Permit of Authorization to Construct an On-Site Sewage Facility Permit Valid For One Year From Date Issued

Permit Number: 118309

ON-SITE SEWAGE FACILITY APPLICATION

Application for Permit for Authorization to Construct an On-Site

ASSIGNED ADDRESS: 11550 REBECCA CREEK RD SPRING BRANCH, TX 78070

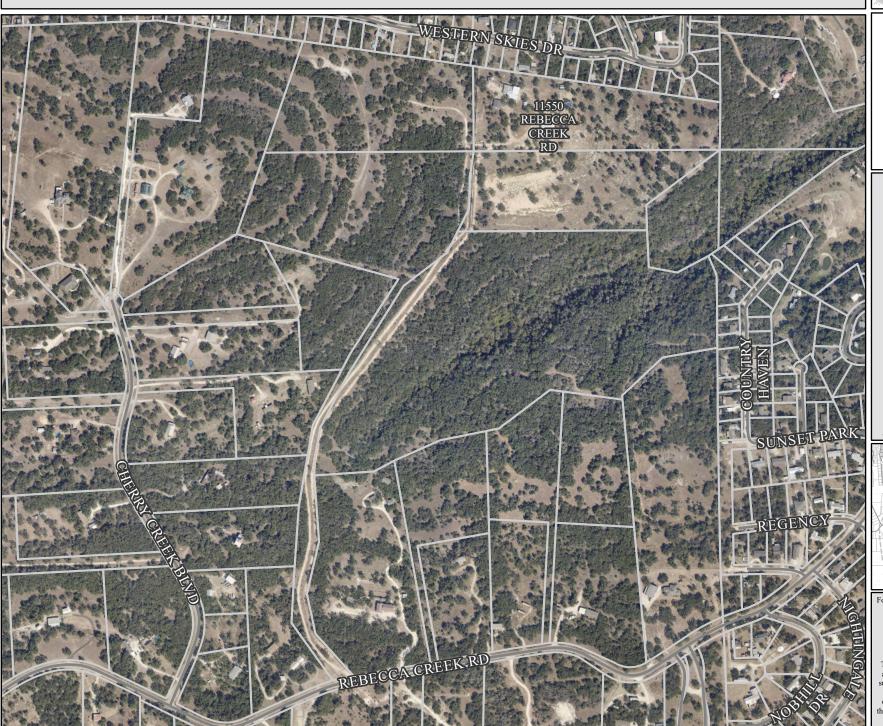
See attached address information for the referenced property. Before further processing of the permit submittal the permit application and associated planning materials must be revised to reflect the attached assigned address. Please revise as needed and resubmit.

here is a revision for this permit with all the documents corrected with the 911 address
